UNITED STATES
NUCLEAR REGULATORY COMMISSION
WASHINGTON, D. C. 20555

APPLICANT: Public Service Electric & Gas Company (PSE&G)
FACILITY: Hope Creek Generating Station
SUBJECT: SUMMARY OF STRUCTURAL AND GEOTECHNICAL ENGINEERING
BRANCH (SGEB) MEETING

On August 1, 1984, a meeting was held in the Bethesda, Maryland offices of the NRC to discuss the remaining SGEB-Structural audit open items identified in the Draft SER. A list of meeting attendees is included as Enclosure 1 to this meeting summary.

FIGURE A-16-17

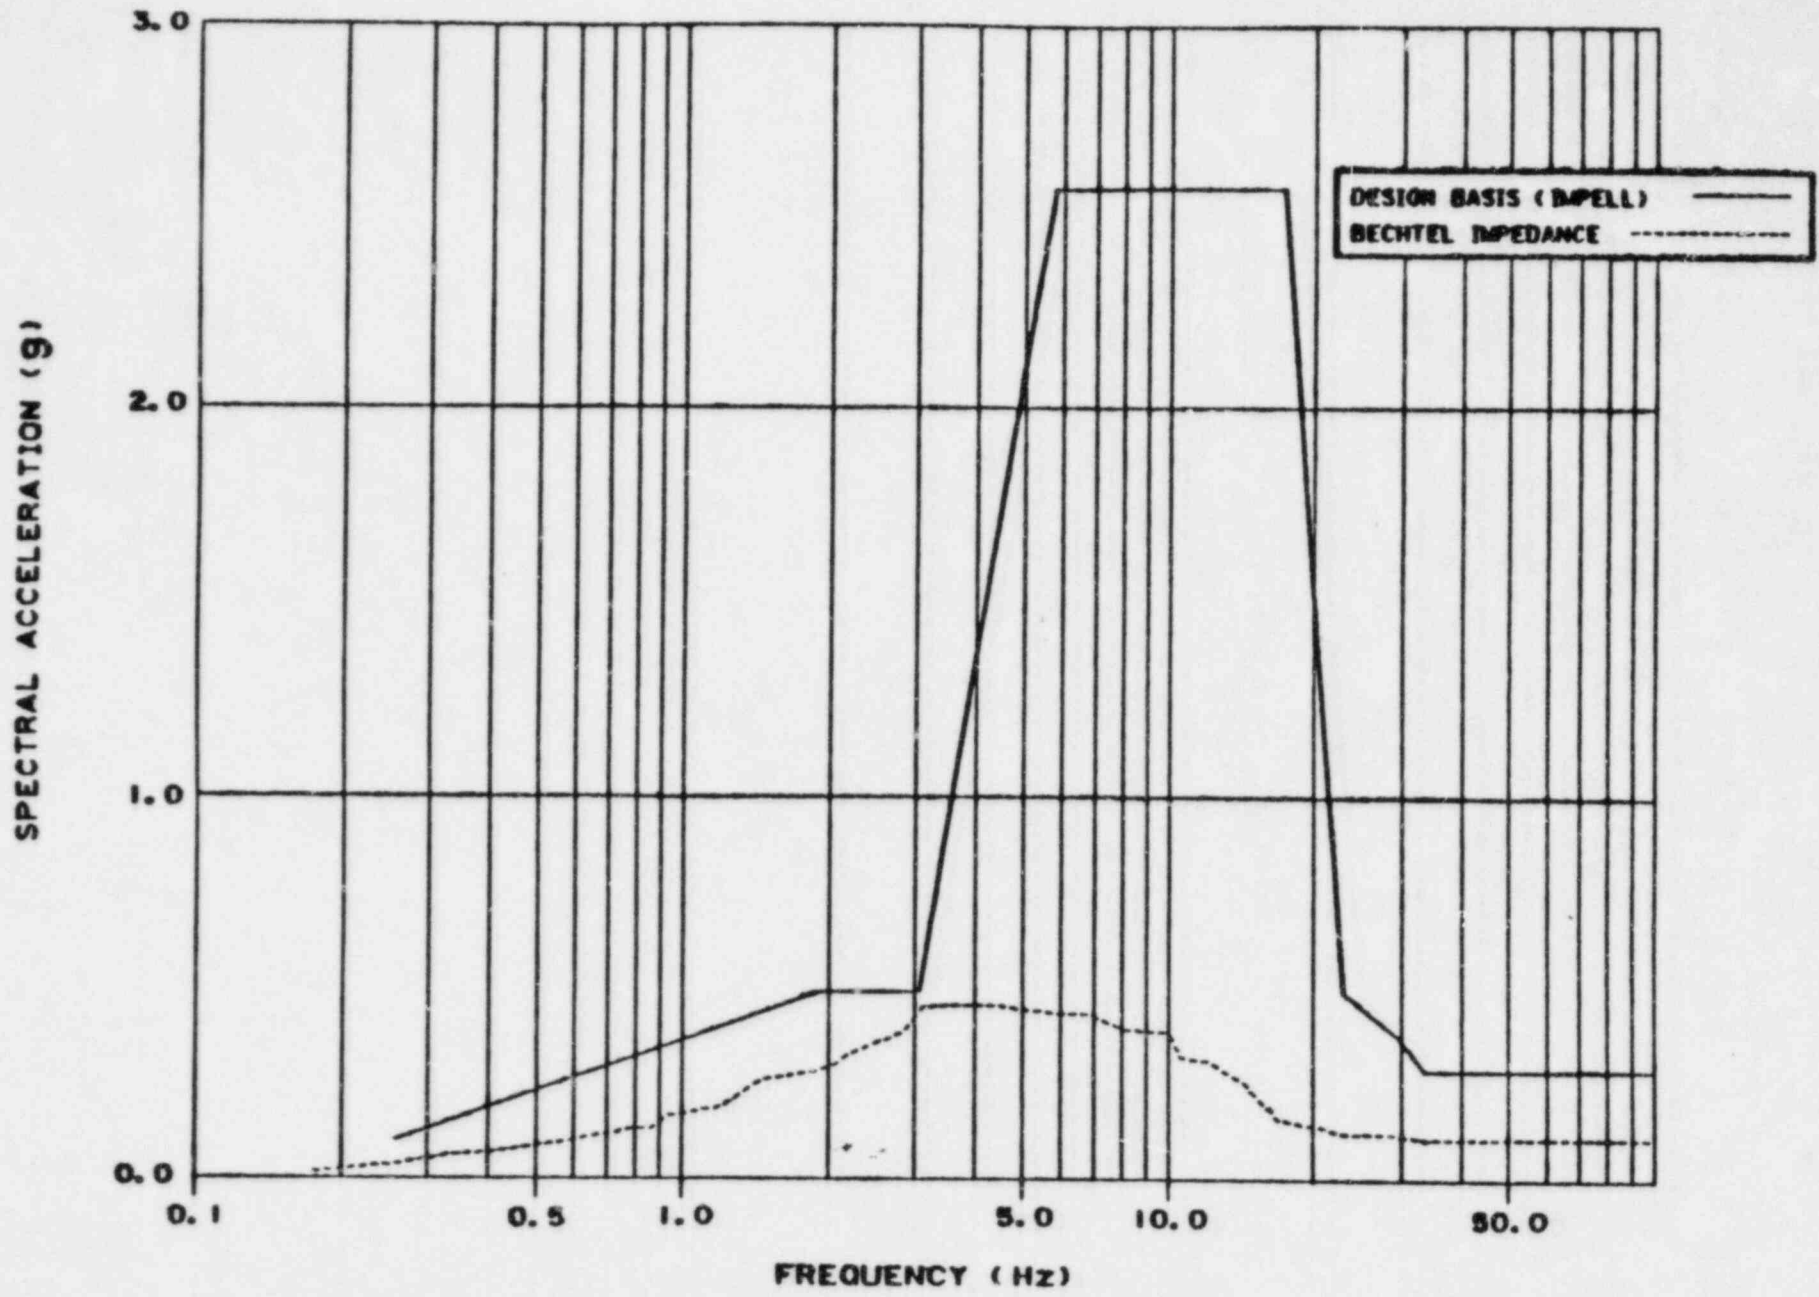
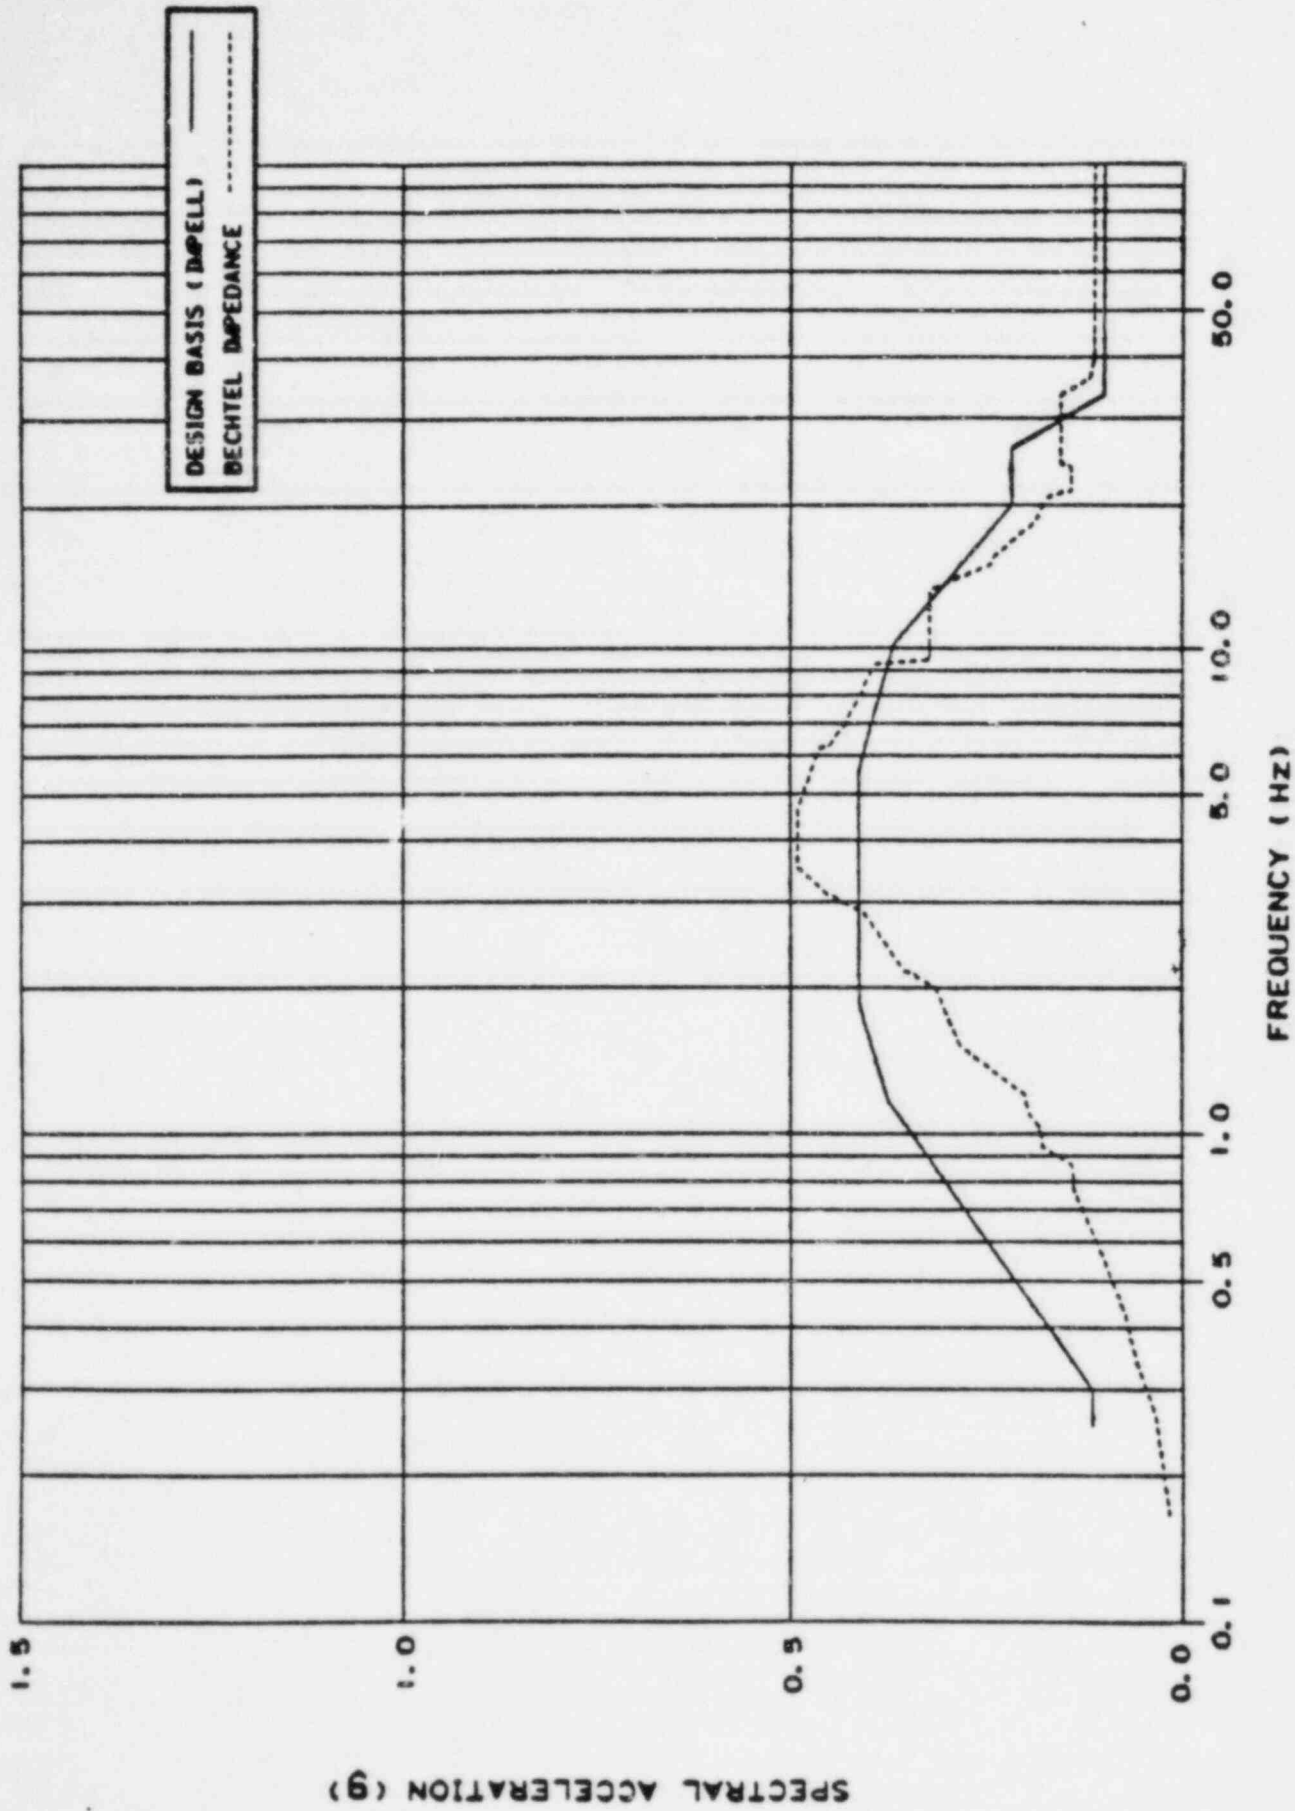
Question No.: A-16

Figures A-16-1 to A-16-18 show the comparison of the 2 percent damping response spectra obtained from the design basis finite element and the impedance approach seismic soil-structure interaction analyses. The impedance approach response spectra generally are enveloped by those obtained from the design basis analyses at elevation 114.0 feet of the SWIS. For other elevations, the impedance approach spectral accelerations exceed the design basis spectral accelerations in some frequency ranges. These ranges vary approximately between 1.5 and 10.0 Hz.
